# UNITED STATES PATENT AND TRADEMARK OFFICE

APPLICATION NO.	FILING DATE	FIRST NAMED INVENTOR	ATTORNEY DOCKET NO.	CONFIRMATION NO.
09/847,505	05/02/2001	John C. Voudouris	72270-9004-01	8515
23409	7590	01/13/2005	EXAMINER	
MICHAEL BEST & FRIEDRICH, LLP 100 E WISCONSIN AVENUE MILWAUKEE, WI 53202			LEWIS, RALPH A	
			ART UNIT	PAPER NUMBER

<b>Office Action Summary</b>	Application No. 09/847,505	Applicant(s) <i>W</i> VOUDOURIS, JOHN C.	
	Examiner Ralph A. Lewis	Art Unit 3732

Note Figure 5 of Rosenberg reproduced below with identified elements meeting the claim limitations.

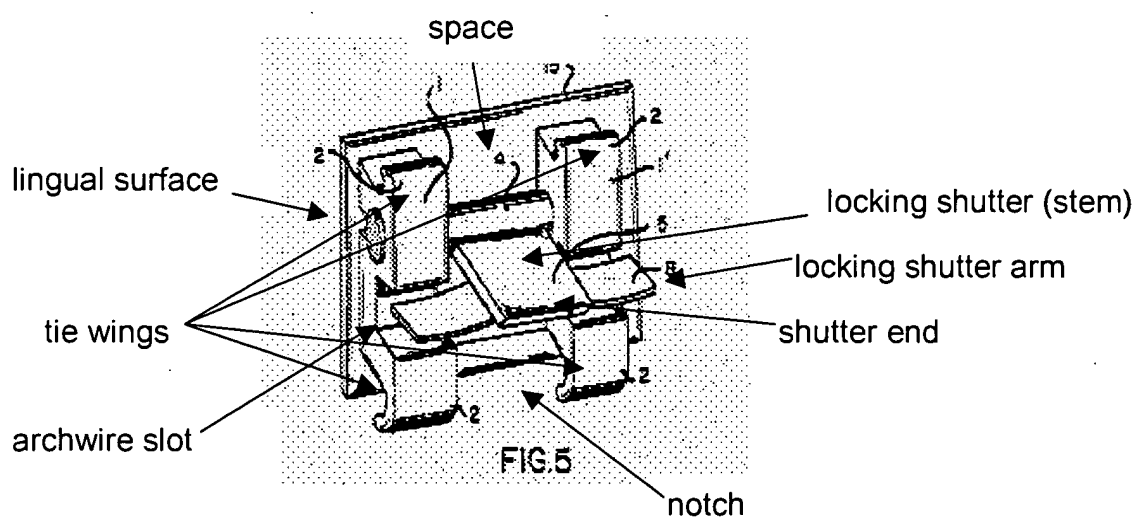
Claims 41-57 and 59 are rejected under 35 U.S.C. 102(b) as being anticipated by Rosenberg (4,634,662).

In response to the present rejection, applicant argues that "Rosenberg does not teach, suggest or disclose a body and tie wings collectively forming a labial surface having a notch formed therein." Perhaps applicant missed the word "notch" and accompanying arrow pointing to a "notch" in the Figure 5 provided by the examiner above as applicant did not even address the Figure provided. If applicant is of the position that the general terminology "notch" be interpreted much more narrowly, then it is suggested that the term be more narrowly defined in the claim. The examiner is required to give common terms such as "notch" their broadest reasonable interpretation.

Applicant further argues with respect to claim 48, that Rosenberg fails to disclose a labial surface that is "concave about an axis that is parallel to a mesio-distal axis." The examiner can find no basis for such "mesio-distal axis" language in the specification. In the Examiner's "Illustrated dictionary of Dentistry" by Jablonski, W.B Saunders Company, © 1982 no such terminology has been defined. The term "mesioaxial" is defined as "pertaining to or formed by the mesial and axial walls of a tooth cavity preparation" such language suggests a vertical axis for an upright patient. "Mesial" is defined as "toward or situated in the middle, median, nearer the middle line of the body or nearer the center of the dental arch." With no definition given for the terminology "mesio-distal axis" the examiner gives it its broadest reasonable interpretation as relating to a vertical axis and notes the Rosenberg Figure 5 device illustrated above includes concave surfaces on the locking shutter arm that meet the orientation requirement when in a closed position.

In regard to claim 54 applicant argues that "Rosenberg does not teach, suggest or disclose an archwire slot including a notch, or a shutter including an end positioned in the notch when the shutter is in the closed position." The examiner invites applicant to review the drawing reproduced above which illustrates elements distinctly labeled as "shutter end" and "notch" which expressly meets the physical limitation.
